| Project                      | <b>IEEE 802.16 Broadband Wireless Access Working Group</b> < <a href="http://ieee802.org/16">http://ieee802.org/16</a> >

Figure 1. Initial-ranging transmission for OFDMA in the current draft.

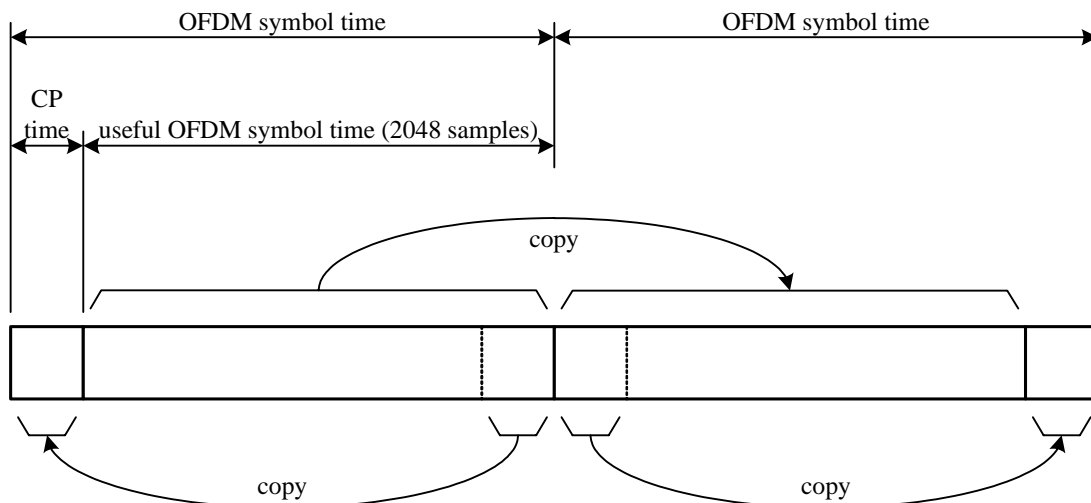
Arrival timings of initial-ranging signals at a BS are not subject to be aligned with the OFDM symbol timing at the BS. The only information each SS under initial-ranging has is the received downlink OFDM symbol timing, which the initial-ranging signal is to be aligned with. Therefore, the initial-ranging signals from the SS's very close to the BS arrive at BS with little timing offset while the initial-ranging signals from the outermost SS's on the cell boundary arrive at BS with a timing offset equal to the round trip delay. The current draft specifies the initial-ranging transmission to last for two OFDM symbol times by repeating itself without phase discontinuity as shown in Figure 1 in order to guarantee a full continuous-phase signal over the intended OFDM symbol epoch<sup>1</sup> for successful detection and timing offset estimation of the initial-ranging transmission. Figure 2 shows a favorable example, where the initial-ranging transmissions from different SS's are either modulated with different ranging codes or separated by more than an OFDM symbol time. The RNG-A, RNG-B, and RNG-C respectively denotes the initial-ranging transmissions from SS's A, B, and C.

Figure 3. Example of successive initial-ranging transmissions adjacent in time.

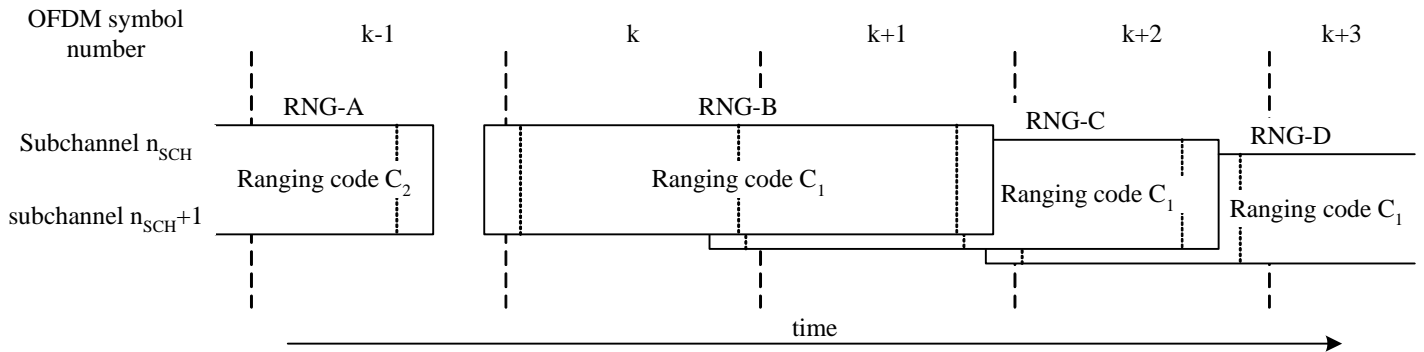
Let us consider the example shown in Figure 3, where three different SS's initiate initial-ranging at three successive OFDM symbol epochs with an identical ranging code. Ideally, all three initial-ranging transmission should be successfully detected since the SS's have chosen three different epochs. However, with the current design of initial-ranging transmission, the incomplete portions of RNG-B and RNG-C in the  $(k+1)$ st and  $(k+2)$ nd OFDM symbol epochs degrade the detection of RNG-C and RNG-D, respectively.

Figure 4. Proposed initial-ranging transmission for OFDMA

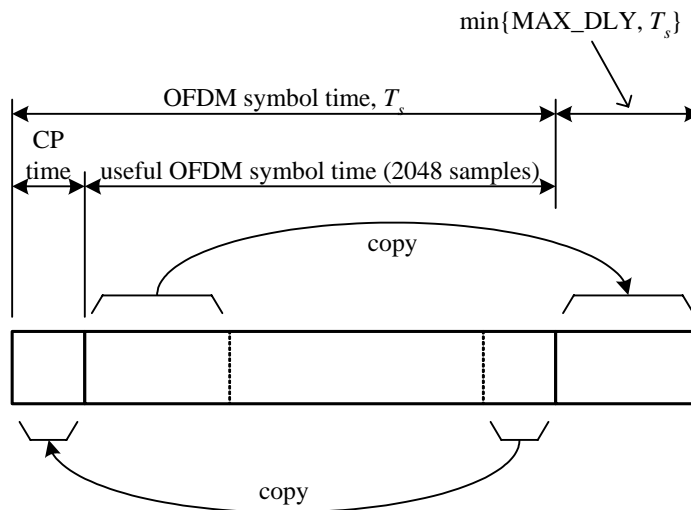
Unlike the preceding portion of the initial-ranging transmission in the  $(k-1)$ st OFDM symbol epoch, the portion in the  $(k+1)$ st OFDM symbol epoch can be shortened to reduce the interference to other uplink transmissions. Since the only purpose of the second repetition in initial-ranging transmission is to guarantee a complete continuous-phase signal during the intended OFDM symbol epoch at the BS, the length of the initial-ranging transmission have only to be  $T_s + 2 \times \text{MAX\_DLY}$ , where  $T_s$  denotes the OFDM symbol time and  $\text{MAX\_DLY}$  denotes the maximum propagation delay between the BS and an SS within the cell.  $\text{MAX\_DLY}$  shall be equal to the round trip delay between the BS and the outermost SS on the cell boundary or larger. The length of the initial-ranging transmission is limited to  $2T_s$ . Figure 4 shows the proposed initial-ranging transmission for improvement in initial-ranging performance.

Replace Figure 128bc with Figure 4, and delete the second and the third sentences in 8.5.7.1 so that 8.5.7.1 would read as follows:

Replace Figure 128bc with the revised Figure 4, with “MAX\_DLY” replaced with “TTG” and delete the second and the third sentences in 8.5.7.1 so that it would read as follows:

“The initial-ranging transmission shall be used by any SS that wants to synchronize to the system channel for the first time. A time-domain illustration of the initial-ranging transmission is shown in Figure 128bc.”

“The initial-ranging transmission shall be used by any SS that wants to synchronize to the system channel for the first time. A time-domain illustration of the initial-ranging transmission is shown in Figure 128bc.”
